SAFETY INFORMATION

SAFETY INFORMATION BULLETINS

SERVICE BULLETIN NO: 9401

SUBJECT: Swift Plus reserves with Spectra lines must be inspected for possible faulty bartacks.

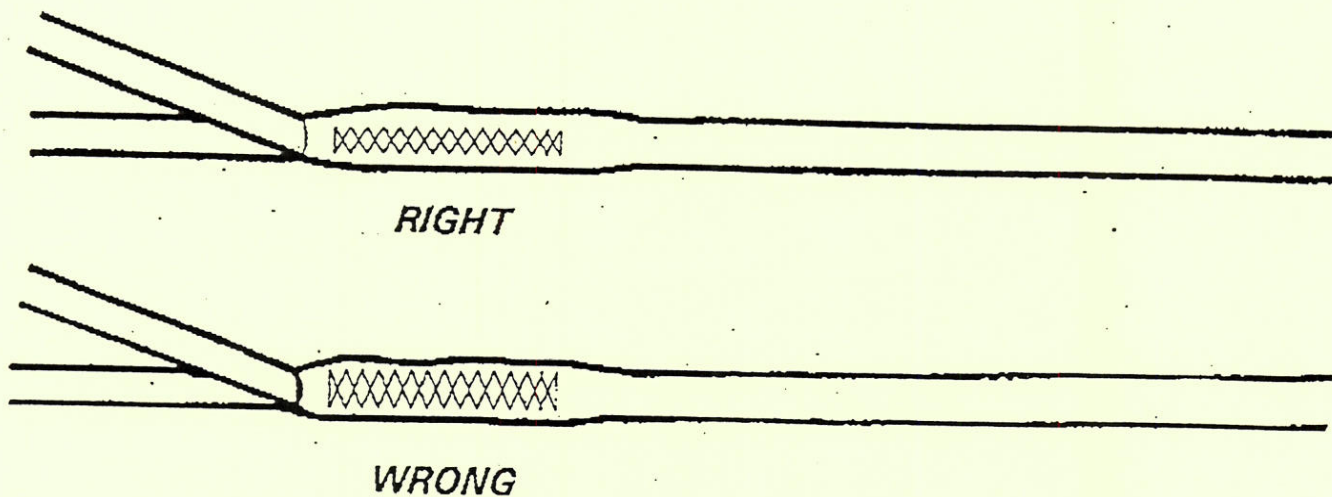
A Swift Plus 225 reserve, serial No. R7-2218, manufactured February 19, 1992, was found to have a faulty bartack at the outer D line cascade. The width of the bartack was too wide to catch the finger trapped insertion of the cascade, allowing the cascade to be pulled free by hand.

On the affected reserve parachutes the A and C lines are continuous and the B and D lines are cascaded and finger trapped into them. Therefore, the failure of this junction is not catastrophic and will not lead to a malfunction.

All bartacks of the suspension line sets must be subjected to a visual inspection and compared to the enclosed drawing. "Good" bartacks will have a centered appearance and ample material on both sides of the stitches.

In the case of a defective bar tack notify Para-Flite immediately providing the serial number of the affected parachute and a description of the location of the bartack and the nature of the defect. If you are not sure, please call before cutting the existing bartack.

The defective bartack may be replaced by any properly equipped and authorized repair facility and the bartack replacement costs can be invoiced or passed onto Para-Flite. Alternatively, the parachute may be sent to Para-Flite for repair, where it will be repaired free of charge.
